Access Compliance Report

Public Rights-of-Way

Intersection ID: 16907	Main Street: BOSTON_AV	Cross Street: IDLEWILD_RD	Location: NW
ADA ID: 4F3B65E87002	Ramp Type: PerpDiag	Initial Pass/Fail: Fail	Overall Compliance: No
		Severity Score: 12.5

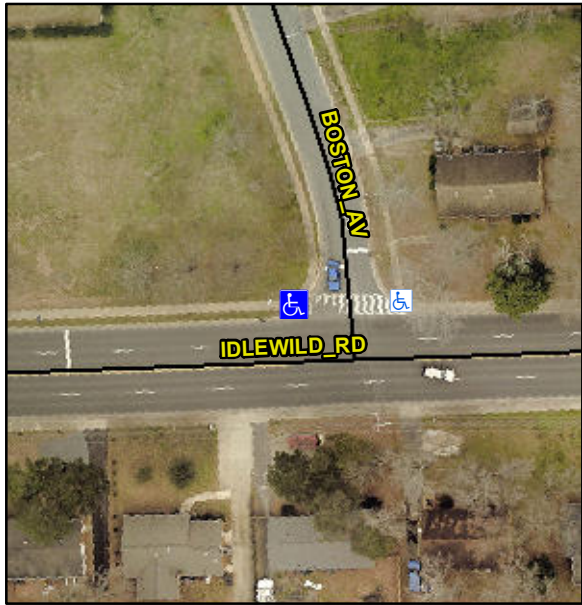
Codes/Mitigation Info/Possible Solution		Field Measurements/Component Compliance					
	Possible Solutions:						
	Remove & Replace Curb Ramp With Two New Directional Ramps or Equivalent.	N/A	Ramp Length (in)	61.0	No	Ramp Slope (%)	10.6
		Yes	Ramp Width (in)	48.0	Yes	Ramp XSlope (%)	0.9
		N/A	Flare Type LT	N/A	N/A	Flare Type RT	N/A
		N/A	Flare Slope LT (%)	N/A	N/A	Flare Slope RT (%)	N/A
		N/A	Flare Traversable LT?	N/A	N/A	Flare Traversable RT?	N/A
		N/A	Landing Length (in)	N/A	N/A	DWS Provided?	N/A
		N/A	Landing Width (in)	N/A	N/A	DWS Contrast?	N/A
		N/A	Landing Slope (%)	N/A	N/A	DWS Length (in)	N/A
		N/A	Landing X Slope (%)	N/A	N/A	DWS Full Width?	N/A
<p>Surveyor Notes:</p> <p>N/A</p>		N/A	Landing Curb? (Y/N)	N/A	N/A	DWS Offset (in)	N/A
		N/A	Shared Landing?	N/A			
		N/A	Gutter Ponding?	N/A	N/A	Gutter Slope (%)	N/A
		N/A	Gutter Lip Ht (in)	N/A	N/A	Gutter X Slope (%)	N/A
		N/A	Painted X Walk1?	No	N/A	Painted X Walk2?	Yes

X Walk 1 Direction	To S		X Walk 2 Direction	To E
		N/A	X Walk 1 Width (in)	N/A	N/A	X Walk 2 Width (in)	108.0
			X Walk 1 Slope (%)	0.0		X Walk 2 Slope (%)	0.8
			X Walk 1 X Slope (%)	1.0		X Walk 2 X Slope (%)	1.9
		N/A	Ramp inside XWalk1?	N/A	N/A	Ramp inside XWalk2?	Yes
<p>PROW/ADA:</p> <p>Not Found, R304.2.2</p>			Road Slope (%)	0.8	N/A	Clear Space?	N/A
			Road X Slope (%)	0.9	N/A	Clear Space to XWalk (in)	N/A
		N/A	Any Obstructions?	N/A	N/A	Storm Grate/Utility Hazard?	N/A
			Obstruction Type			Storm Grate/Utility Type	
				N/A			N/A
					Yes	Surface Condition? (G/P)	Good
	Total Cost:		\$	3200.00
